UNITED STATES PATENT AND TRADEMARK OFFICE

10/586,871

Office Action Summary	Application No. 10/586,871	Applicant(s) MERZ ET AL.	
	Examiner KEITH COLEMAN	Art Unit 3747

DETAILED ACTION

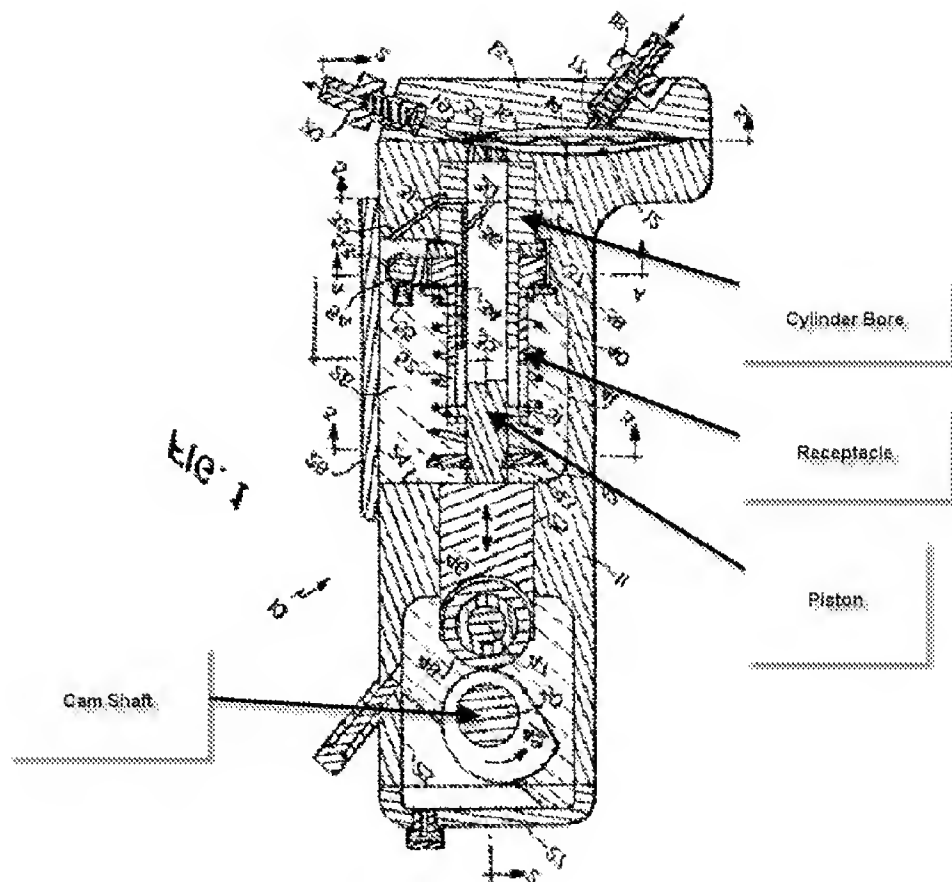
Applicant has amended the claim language to overcome the previous cited reference by adding the limitation of "wherein an end of the cylinder bore oriented toward the drive shaft terminates at a plane containing a wall of the receptacle"

The patent to Kovacs et al. clearly shows Applicant's claimed subject matter in Figure 1.

Fig. 2

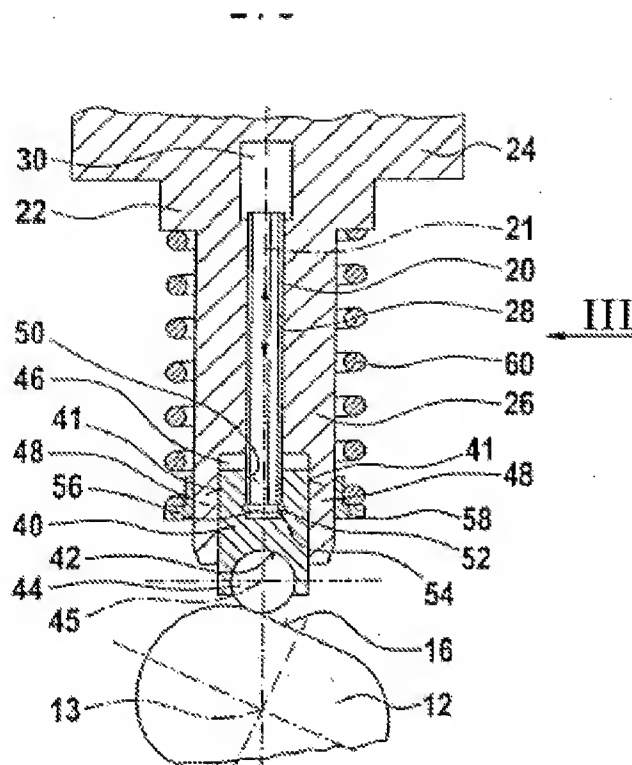
Applicant's Drawing as shown in Figure 2
